**CALIFORNIA COASTAL COMMISSION**

**STAFF REPORT  
 PERMIT AMENDMENT**

**Application number** ..... **4-83-490-A1, Cliffs Hotel Revetment & Dewatering Plan**

**Staff recommendation** ... **Denial of Revetment, Approval of Dewatering Plan with Conditions**

GENERAL RETENMENT CROSS SECTION

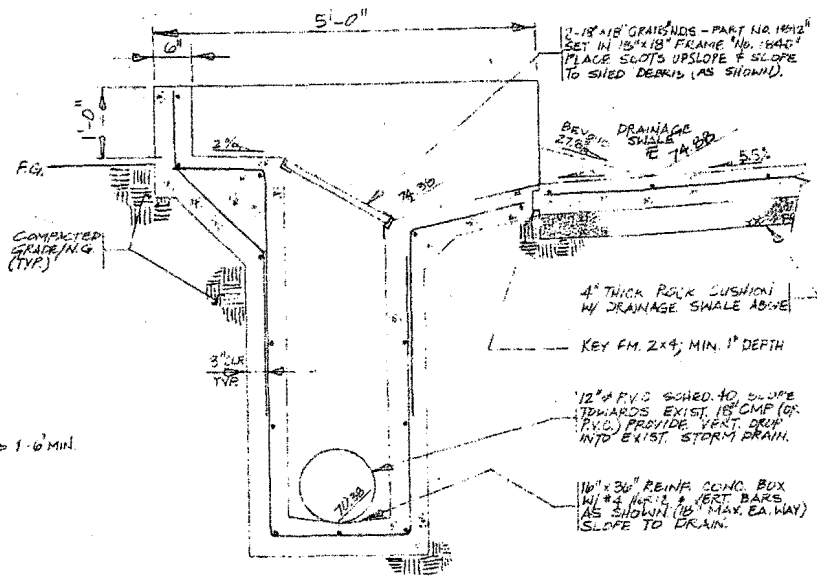
Staff is recommending that the revetment be denied because of this essential inconsistency with the original Commission approval of the Cliffs Hotel. The revetment must also be denied, though, because no showing has been made that any existing principal structures are in danger from erosion. As discussed at length in these findings, even using the Applicant's geotechnical information, the principal structures here are not in imminent danger. Further, because the "no project" alternative is feasible, the revetment is not necessary. In addition, there are other drainage and dewatering measures available (and proposed by the Applicant) to minimize erosion risks that are approvable under the LCP (and for which staff is recommending approval). For these reasons, the revetment is inconsistent with the City of Pismo Beach certified LCP.

Finally, the revetment as submitted does not mitigate for its impacts to coastal resources. In particular, the revetment directly encroaches on approximately 4,900 square feet of beach previously dedicated and deed-restricted for public access; it interferes with lateral access; it fails to mitigate distinct and quantifiable sand supply impacts; it is visually incompatible with the natural bluff landform; and fails to provide long-term structural stability. For all of these reasons, the revetment cannot be approved under the City of Pismo Beach certified LCP or the access and recreation policies of the Coastal Act. Finally, were a shoreline structure found to be required and approved by the Commission, and based upon information available today, the appropriate alternative in this case would be to construct a vertical seawall that minimizes beach encroachment and is built to approximate the natural landform. Mitigation for sand supply, public access, and other impacts would also be necessary.

Page 3 of Exhibit 14 illustrates this equation. Based upon the plans submitted by the Applicant, the proposed revetment covers approximately 4,900 square feet of beach. Over the long run, of course, this is a conservative impact, given the likelihood that scour will ultimately expose an increasing depth of the base of the structure, and further given that migration of rock from the revetment will eventually result in a larger footprint. **Nonetheless, using the sand conversion factor of 1.0 (as discussed earlier) the direct loss of beach due to this encroachment translates into a one-time impact of 4,900 cubic yards.**

**EXHIBIT 5**  
**DEWATERING**  
**ELEMENTS**  
**CROSS SECTION**

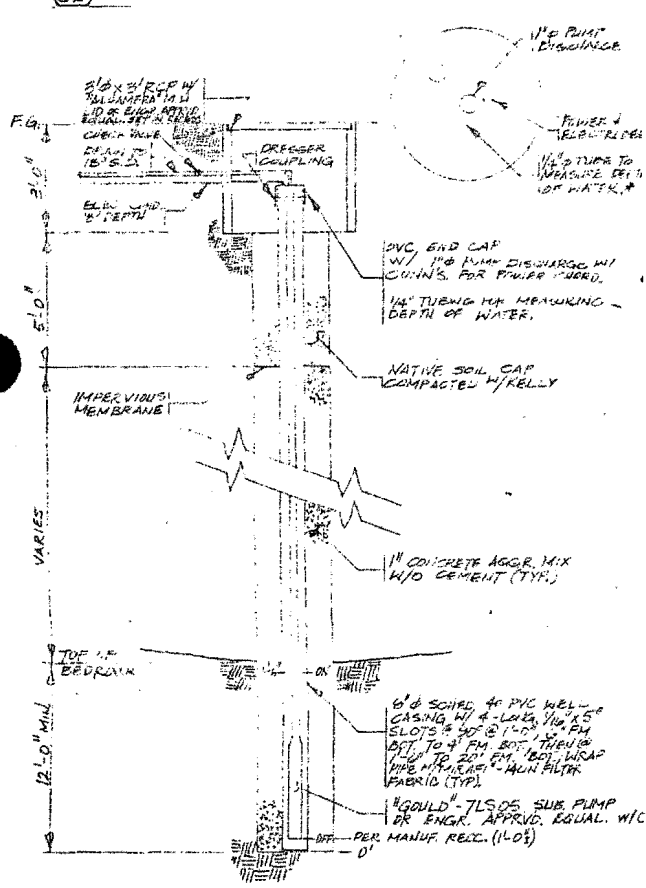
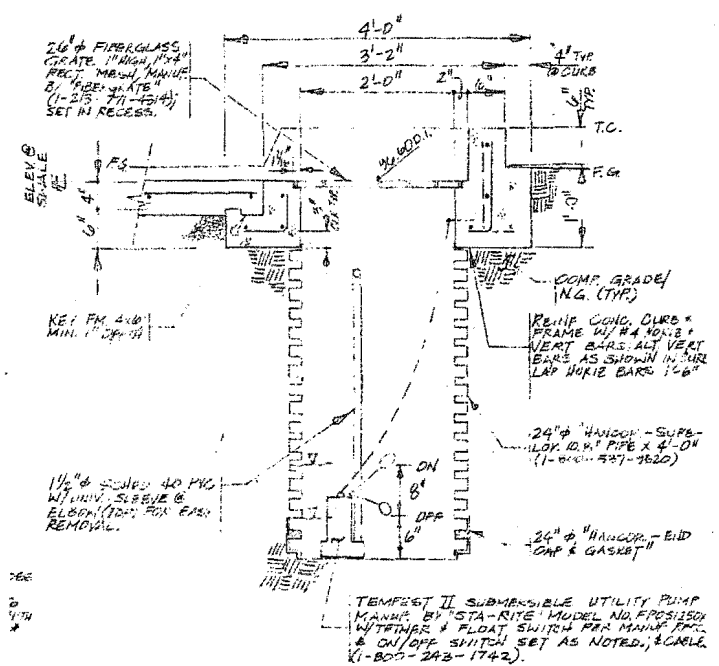
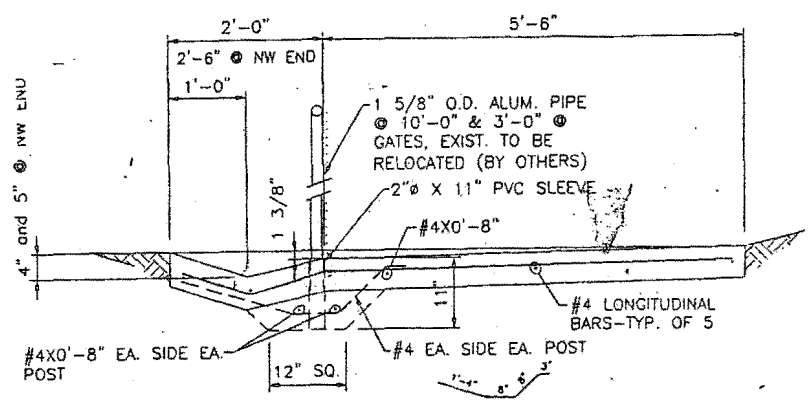
The Applicant also proposes the installation of an emergency generator to serve the sewage lift station. The sewage lift station is not, however, shown on any of the approved plans for the original Cliffs Hotel (4-83-490). It is not clear that the sewage lift station has ever received a coastal permit. As such, it is not possible to approve an emergency generator for an unpermitted structure. If there were some other purpose for the generator as a stand alone apparatus, then its appropriateness could be considered. However, based on the fact that it is specifically designed to serve what appears to be an unpermitted structure, the Commission cannot approve the generator unless and until the lift station is properly permitted. The lift station and any other sewage apparatus are specifically not a part of the project currently before the Commission. Staff anticipate that the enforcement case regarding development in the setback area (V-3-96-003) will be reevaluated following the Commission's action on the current revetment and dewatering application.

3. **Blufftop Landscape and Irrigation Plan.** WITHIN 60 DAYS OF THE COMMISSION'S ACTION ON THIS PERMIT AMENDMENT REQUEST, the permittee shall submit to the Executive Director for review and approval a landscape and irrigation plan prepared by a licensed landscape architect or resource specialist. The plan shall include: (a) planting of drought and salt tolerant native species (consistent with bluff vegetation indigenous to the Pismo Beach area) in the blufftop area seaward of the hotel and restaurant, except that the plan may include the installation of turf in any area inland of the approved path/swale if this turf area is equipped with an impermeable geomembrane consistent with the landscape irrigation control recommendation of the *Geologic Bluff Study* by Earth

Figure 4-2 Encroachment Area-Beach  
Area Lost Due to Placement of a  
Structure on the Beach.

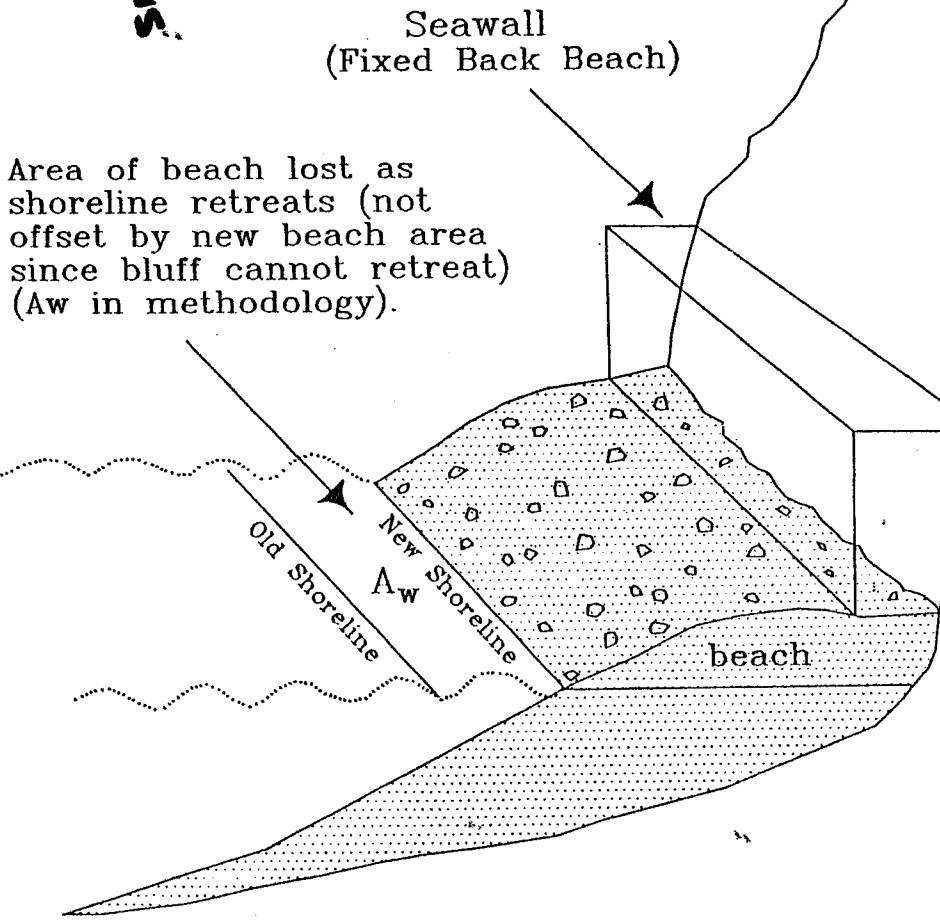
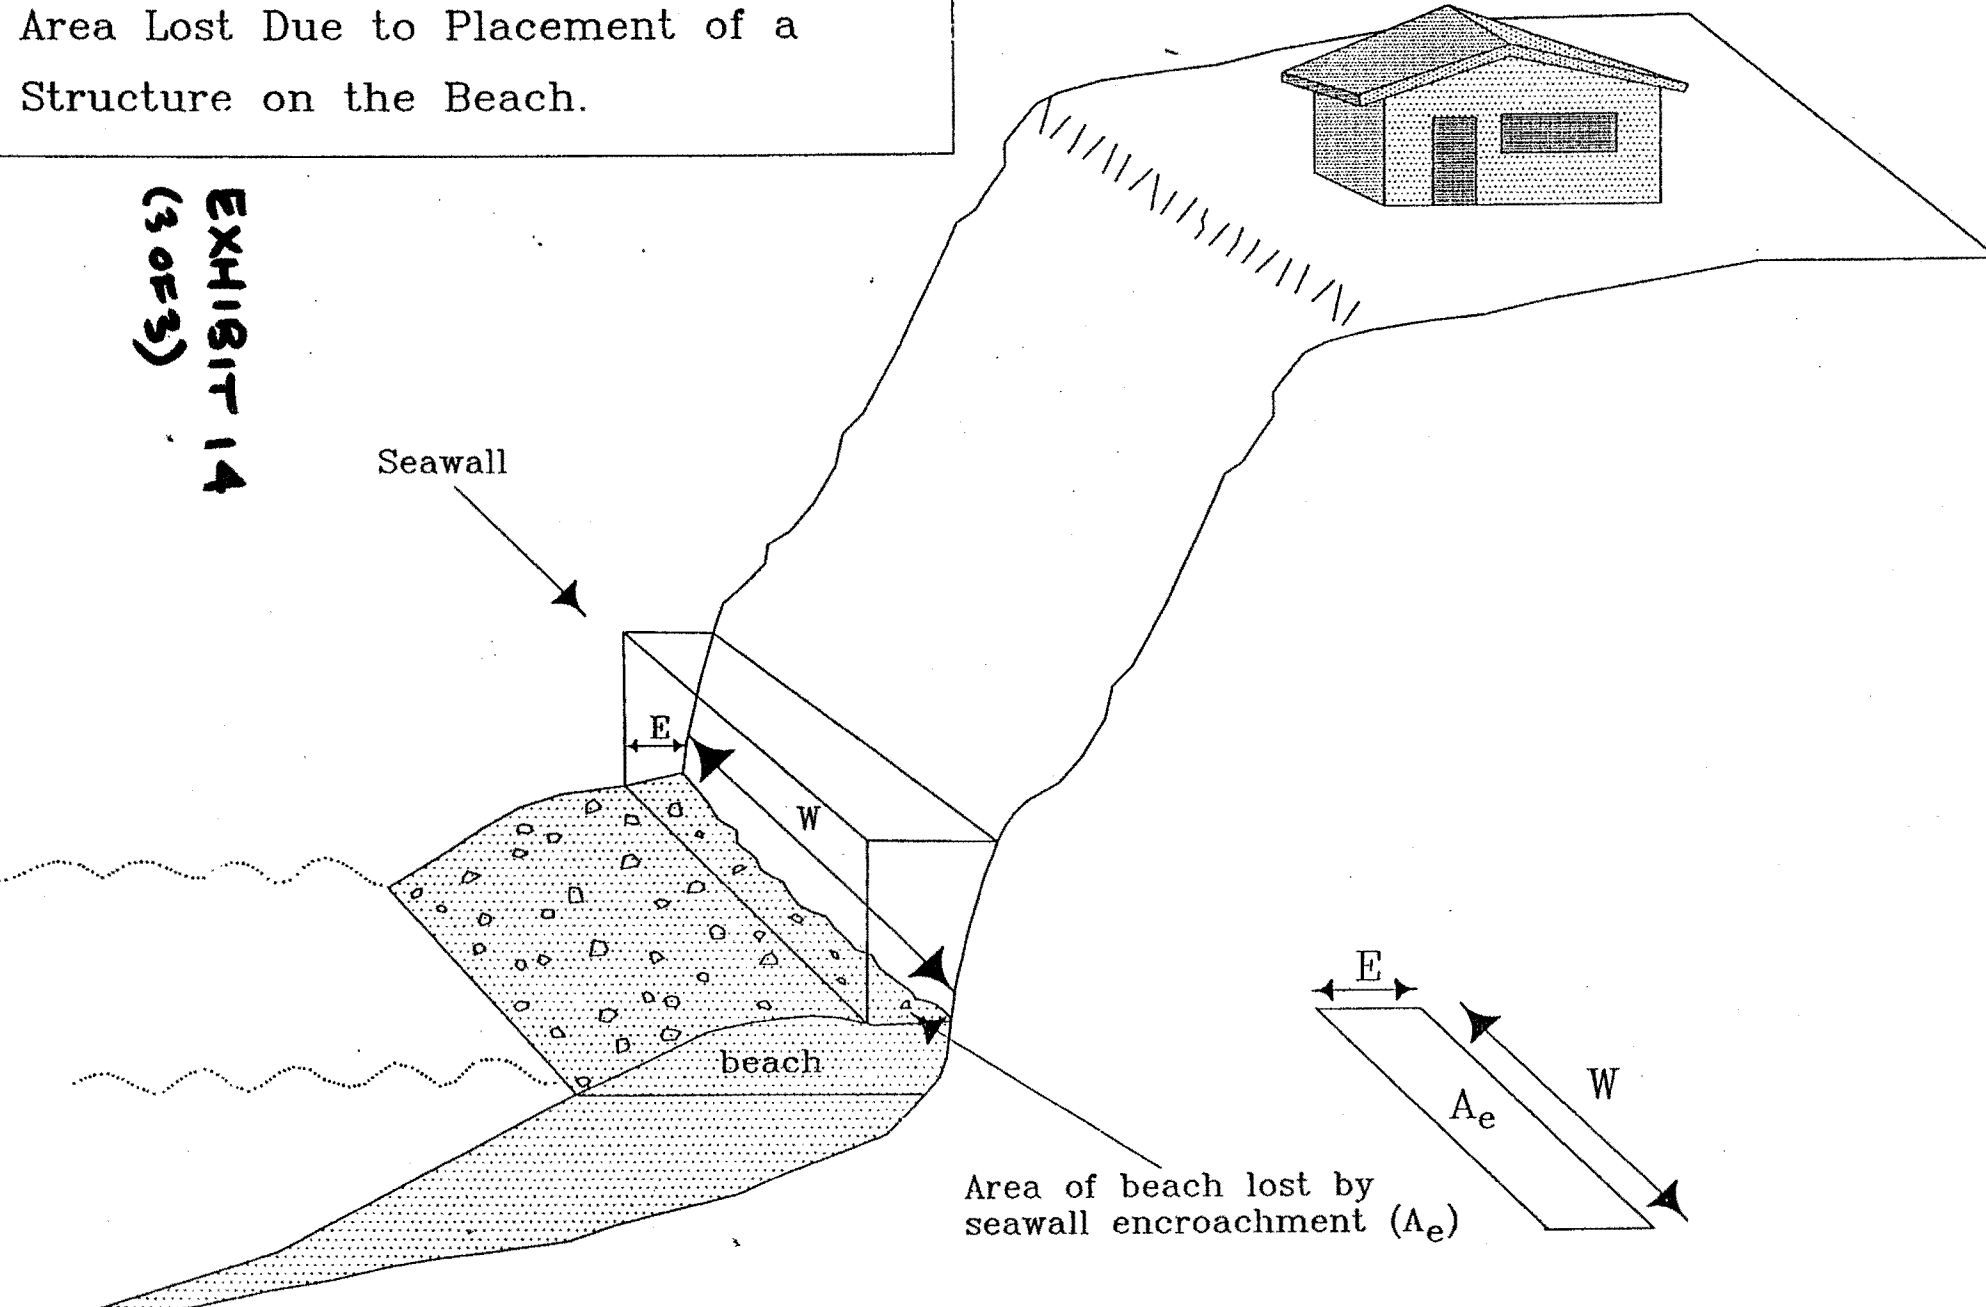
Page 1 of Exhibit 14 generally illustrates this calculation. Since the actual amount of long-term erosion cannot be predicted precisely, erosion is approximated by the long-term average annual erosion rate times the number of years that the back beach or bluff will be fixed. The width of the property which would be fixed can be determined from the proposed project design (approximately 435 linear feet of shoreline according to the proposed plans). The erosion rate has been estimated at 4-feet per year by the Applicant's geotechnical consultant. Although the projected lifetime of the proposed revetment structure has not been determined in this case, if the structure were in place it would result in an annual

To convert the 1,740 square foot loss of beach per year into the volume of sand necessary to restore the beach commensurately in cubic yards, coastal engineers use a conversion value representing units of cubic yards per square foot of beach. This conversion value is based on the regional beach and nearshore profiles, and overall characteristics. When there is not regional data to better quantify this value, it is often assumed to be between 1 and 1.5, the idea being that to build a beach seaward one foot, there must be enough sand to provide a one-foot wedge of sand through the entire region of onshore-offshore transport. If the range of reversible sediment movement is from -30 feet msl to +10 feet msl, then a one-foot beach addition must be added for the full range from -30 to +10 feet, or 40 feet total. This 40-foot by 1 foot square parallelogram could be built with 1.5 cubic yards of sand (40 cubic feet divided by 27 cubic feet per cubic yard). If the range of reversible sediment transport is less than 40 feet, it will take less than 1.5 cubic yards of sand to rebuild one square foot of beach; if the range of reversible sediment transport is larger than 40 feet, it will take more than 1.5 cubic yards of sand to rebuild one square foot of beach.

Although it is not feasible to use sand replenishment as an alternative means of individually protecting structures on the top of the bluff, it is feasible to pursue a sand replenishment strategy that can introduce an equivalent amount of sandy material back into the system as a means of mitigating the loss of material inputs that will be caused by the protective device. Obviously, such an introduction of material, if properly planned, can feed into the littoral cell that supplies sand to not only the publicly used beach at the base of the subject bluff but also the popular beaches throughout the area, thereby mitigating the public access and recreation impacts. However, absent a comprehensive program that provides a means to maximize the benefits of individual mitigation efforts in the area now and in the future, and absent a program that evaluates and guides the use of the most appropriate sites and methods for introducing the material so that it will mitigate this project's impacts and maximize benefits to the sandy beaches, the Commission would not be able to specify a direct in-kind placement of sandy material as mitigation were this revetment to be approvable.
